PROPOSAL REQUEST

PROJECT: Sycamore CSD-HS Seger Natatorium

PROPOSAL REQUEST NO: 10

NATATORIUM
MECHANICAL
PLANS

2 POOL STORAGE PLAN
M100.0 1/8" = 1'-0"

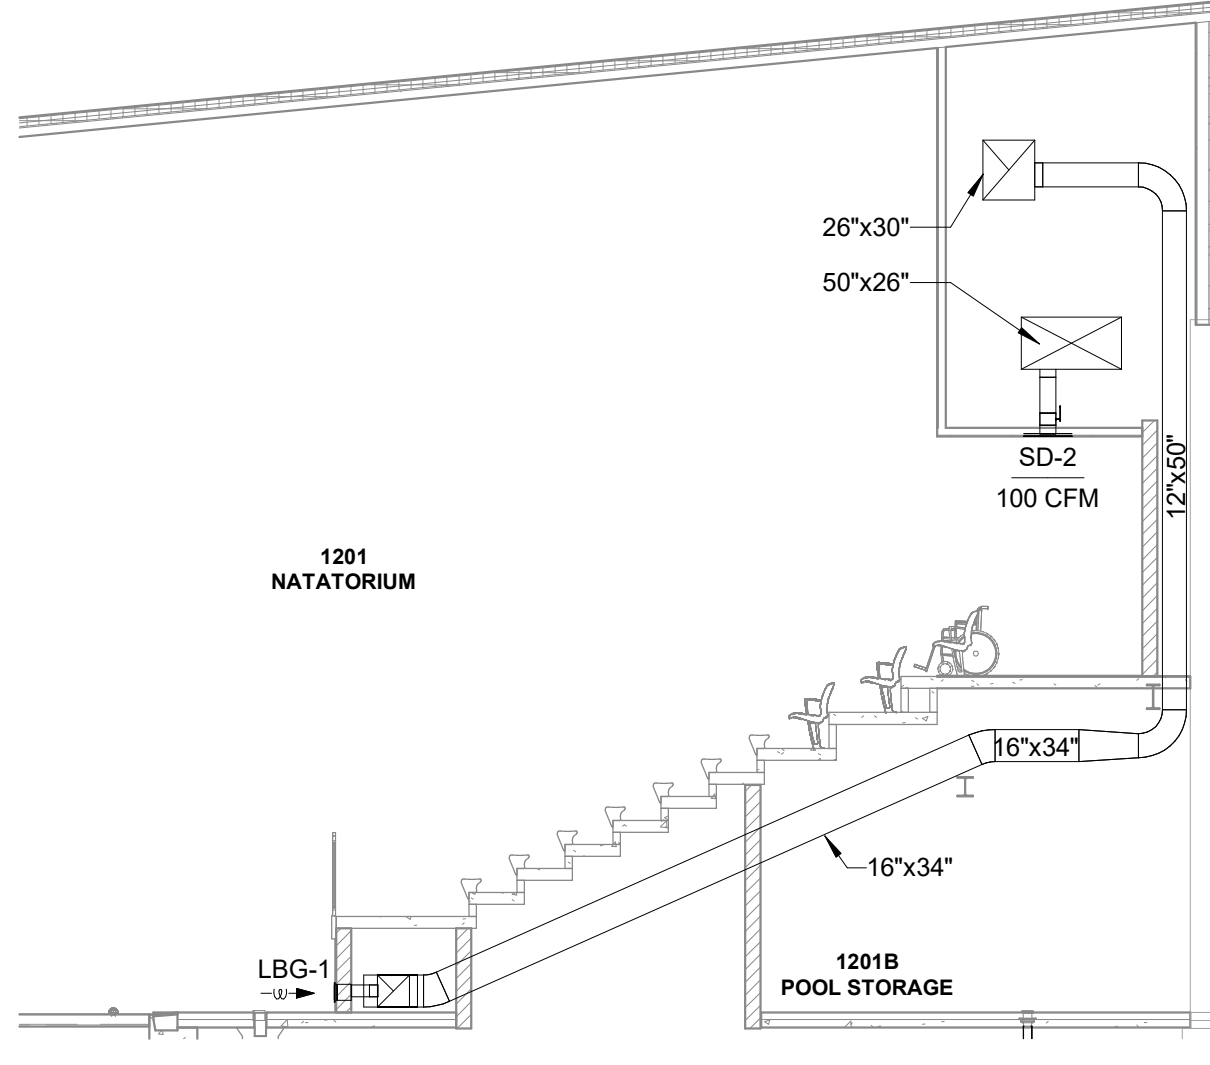
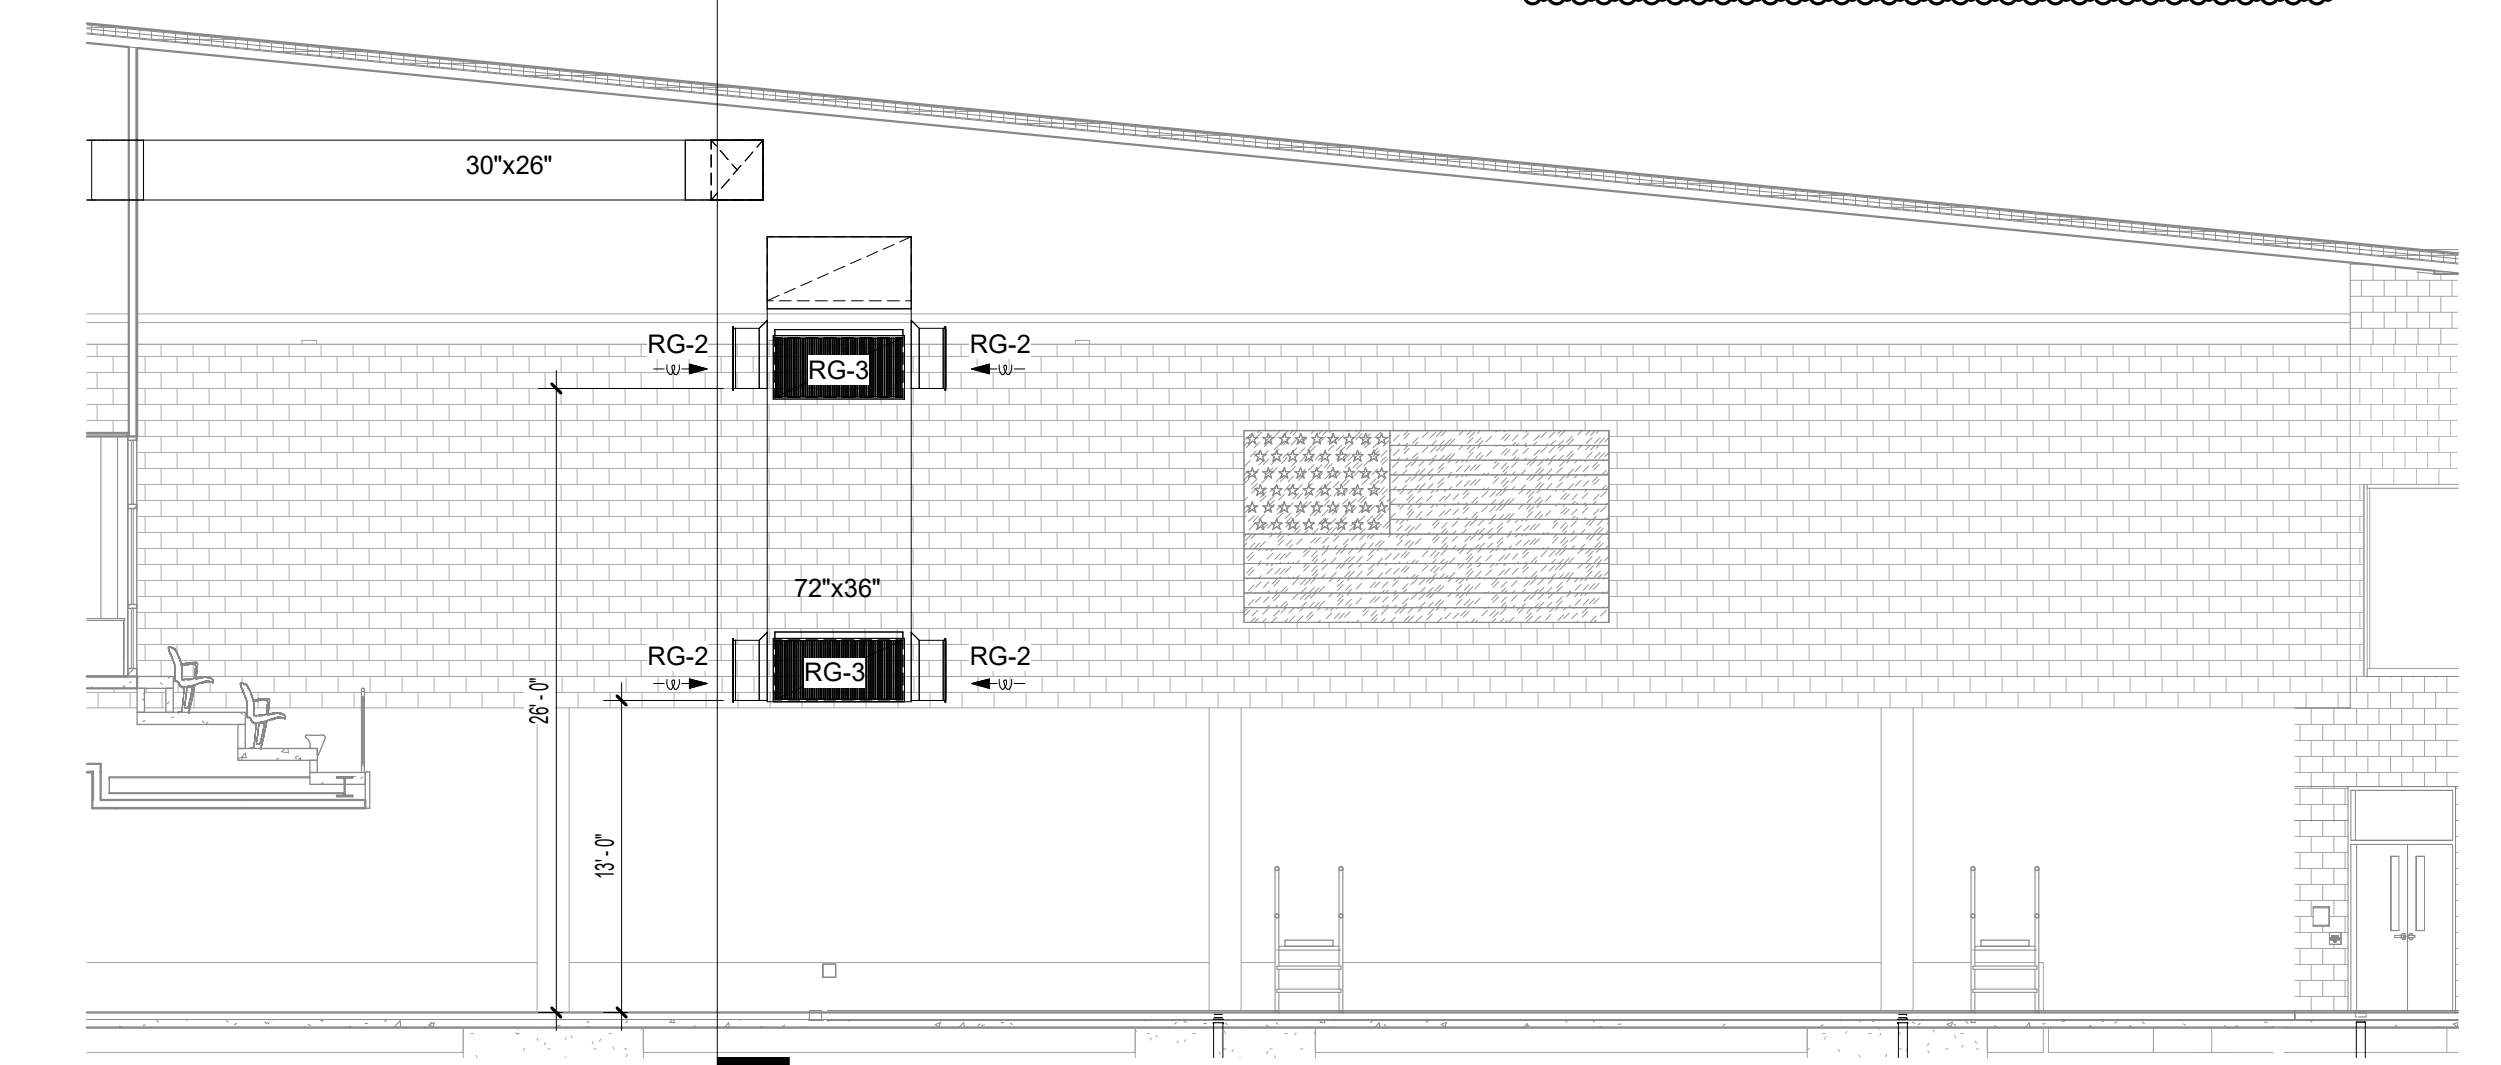
M100.0 has been revised to add exhaust in the pit in 1201A Pump Room.

This was requested by the owner to exhaust any chlorine that may get into that area.

KEYNOTE LEGEND
M6 CONDENSATE PIPE DOWN TO UTILITY SINK IN PUMP ROOM.
M7 PROVIDE TWO PRESSURE SENSORS, ONE IN BREATHING ZONE (APPROX. 4' ABOVE FLOOR) AND ONE AS CLOSE TO ROOF AS POSSIBLE.
M57 BALANCE EXISTING GRILLE TO 650 CFM.
M58 EXTEND DUCT DOWN AND PLACE GRILLE 6' ABOVE THE FLOOR OF THE PIT.
